Rich Cotton Apparels Limited

29 April 2024

2. Observations

Observation-1: The design report required to be revised. (Factory Shed Building)

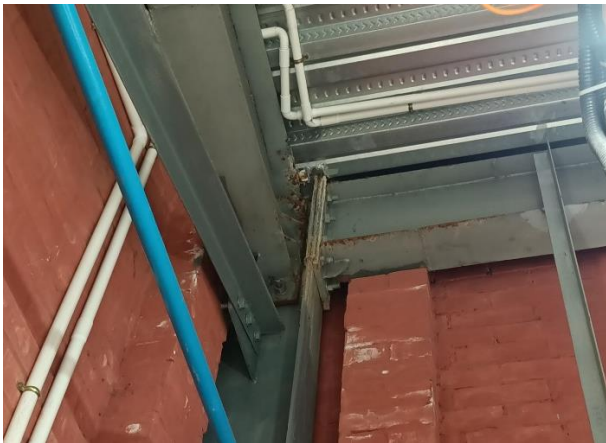
Description: In the design report, the compressive strength of concrete was considered 3500 psi. The factory has provided only 2 sets of concrete cylinder test reports from the footing & slab, but no cylinder test report was found from the short column, which doesn't comply with the frequency of testing requirement of BNBC (section- 5.12.2).

Observation-4: Connection gap and bolt missing. (Factory Shed Building)

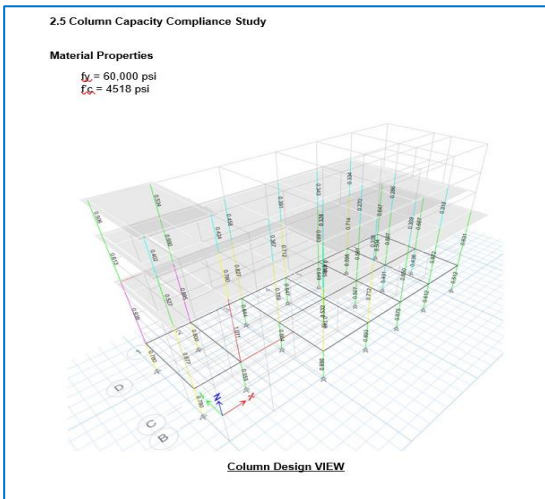
Description: Connection gaps and bolt missing were observed in the steel joint. The building engineer is required to carry out suitable remedial works.

6	Connection gap and bolt missing. (Factory Shed Building)	The building engineer is required to carry out suitable remedial works. Also, install missing bolts where necessary.	within 6 months
7	Non-structural elements not anchored or braced. (Factory Shed Building)	The factory is required to anchor/brace all non-structural elements adequately to resist earthquake forces.	within 6 months
8	The design report required to be revised. (Utility Building)	The building engineer is required to check & confirm the material strength in the design report and revise the design accordingly. Submit the revised documents to the RSC for review.	within 6 weeks
9	The design report required to be revised. (Utility Building)	Implement the remedial works if required.	within 6 months
10	The design report required to be revised. (Utility Building)	Implement floor load plan	within 6 months
11	Lack of information in as-built drawings. (Facility Shed)	The building engineer is required to update the as-built drawing including all connection details.	within 6 weeks

Observation-6: The design report required to be revised. (Utility Building)

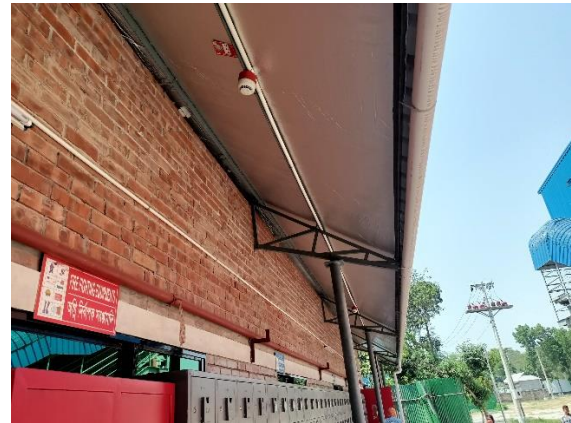
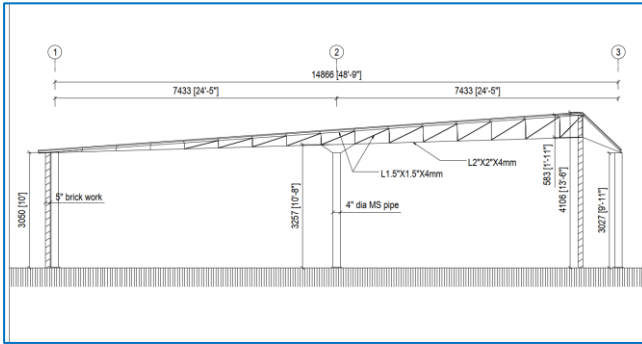
Description: In the design report, the compressive strength of concrete was considered more than 4500 psi. The factory didn't provide any cylinder test report for the building. Also, a 10,000 L PVC water tank was found at the stair top. Slab adequacy check needs to be incorporated in the revised EA and submitted to RSC.

Observation-09: Lack of structural drawings. (Office Shed Part-1)

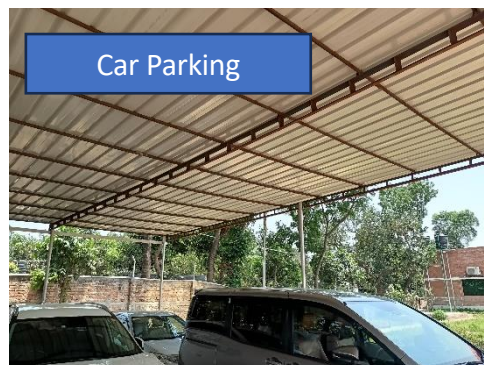
Description: Structural drawings were not available for the Office Shed (South Part). Building engineer is required to prepare a full set of structural drawing for the shed.

12	Lack of lateral stability. (Facility Shed)	Building engineer is required to check the connection adequacy and lateral stability of the structure.	within 6 weeks
13	Lack of lateral stability. (Facility Shed)	Carry out remedial works if required.	within 6 months
14	Lack of structural drawings. (Office Shed-Part-1)	Building engineer is required to prepare a full set of structural drawing for the shed.	within 6 weeks
